NS9750B-A1

Errata

90000738, Rev E

NS9750B-A1 Hardware Reference, Rev. A

UART gap timer

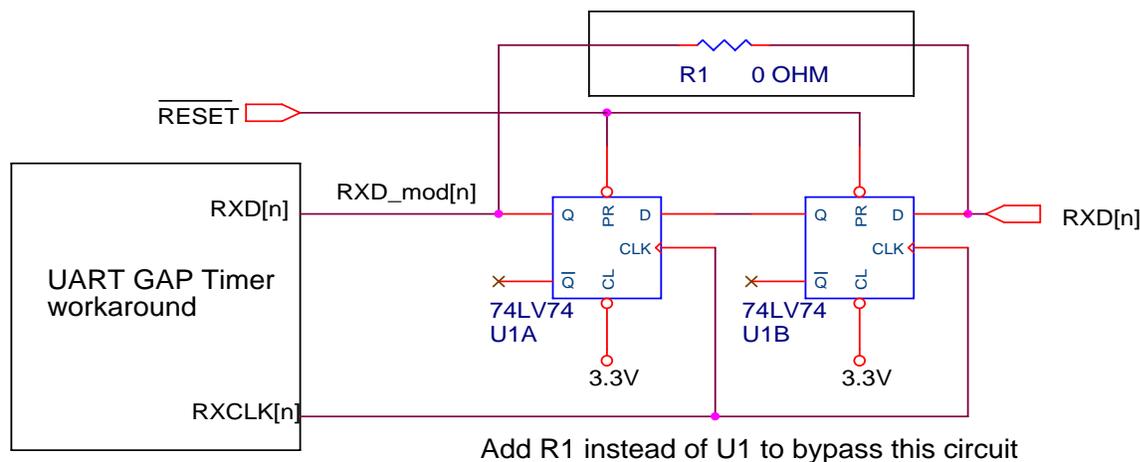
The start bit of a new character may not be detected when the character or buffer gap timer expires. Framing, parity, or data corruption occur when a start bit is missed.

Software workaround: Three conditions have been identified for this erratum:

- Applications with a steady stream of receive data are not affected if the buffer gap timer is disabled.
- Applications where the gap between characters is fixed and the character gap timer period is configured to be less than the fixed period. The buffer gap timer must be disabled.
- Applications that have higher-level protocol error detection and recovery such as PPP can use both the buffer and character gap timers.

A hardware workaround eliminates the possibility of receiving a start bit when a character or buffer gap timer is expiring. The workaround drives the baud clock off-chip and synchronizes the incoming data with this clock. As a result, the buffer and character gap timers and the next start bit have a fixed and known relationship with each other.

UART CTS-related transmit data errors

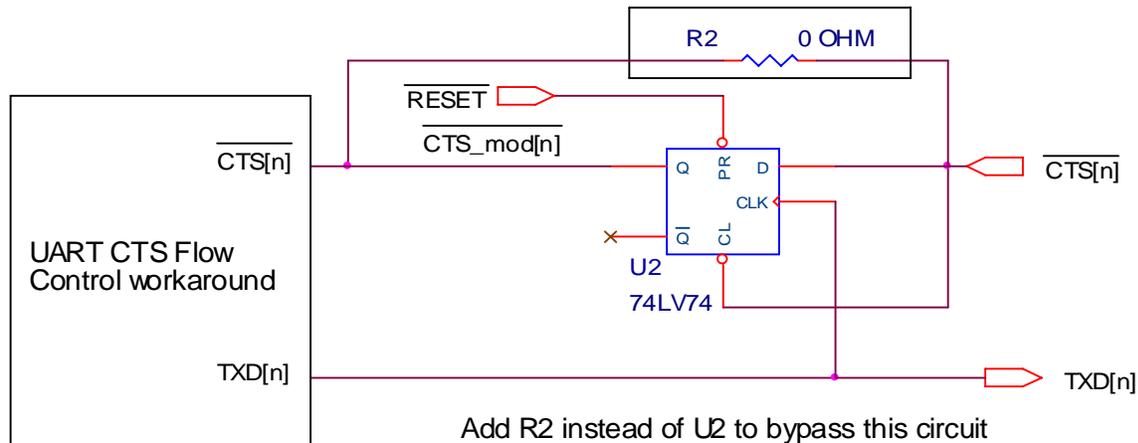
A problem occurs with the CTS flow control signal is de-asserted during the BCLK that begins processing a new character. This problem causes the previous character to be resent instead of getting the next character from the transmit FIFO.

- Modify these bits in Serial Channel Control register A:
 - Set the CTSTX bit (bit 23) to 0 to disable hardware-controlled CTSTX.
 - Set the ERXCTS bit (bit 4) to enable the software CTS signal change interrupt.
 - Update the serial transmit ISR to handle the CTS signal change.
- The maximum bytes in each DMA buffer descriptor is limited to 16 bytes.
- The maximum skid rate can be up to 16 characters.
- The serial monitor thread is changed to handle the missing CTS interrupt.

Hardware workaround: For each UART, externally clock the CTS signal with the Txd_n signal to guarantee that CTS will not be seen de-asserting at the start of a character.

USB OVR and USB PWR

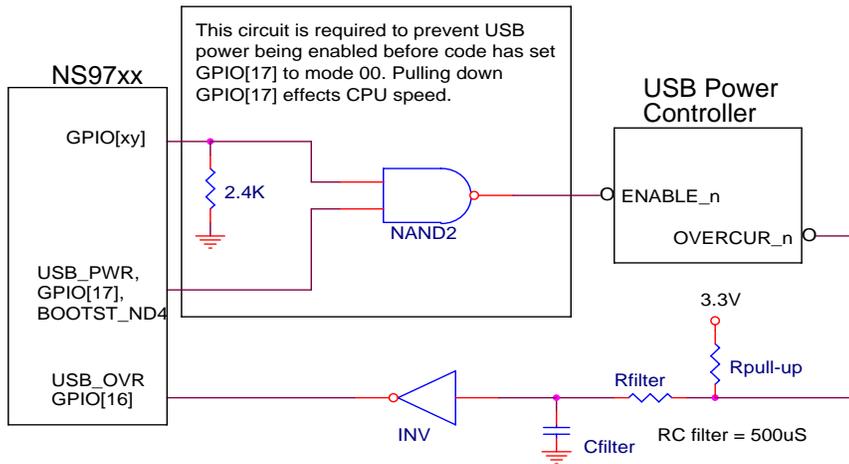
The USB OVR (over current) input on gpio[16] is not shown in the GPIO MUX pinout tables. The polarity of this signal cannot be changed. It is true high, normally requiring an external inverter and noise filter to prevent false indications of over current.

The USB PWR (power) control output requires additional external logic and GPIO to prevent USB power from being enabled from the time power is valid until the code has set the USB registers and selected gpio[17] to mode 00. The polarity of USB PWR is true high. Pulling down GPIO[17] to disable the USB power control changes the CPU bus speed because this pin is also bootstrap – ND4.

Updates are required to the BSP to change gpio[16] from mode 00 to mode 02. Timer 11 is disabled, allowing USB OVR to be recognized by the USP IP. Even though Timer 11 is disabled, the Timer clock select field must be set to 111-External pulse event to set GPIO[16] to an input.

Designs that add the additional GPIO to prevent USB power-on during startup would require the BSP, as a final step, to set this GPIO to output a 1.

This figure shows a recommended logic workaround:
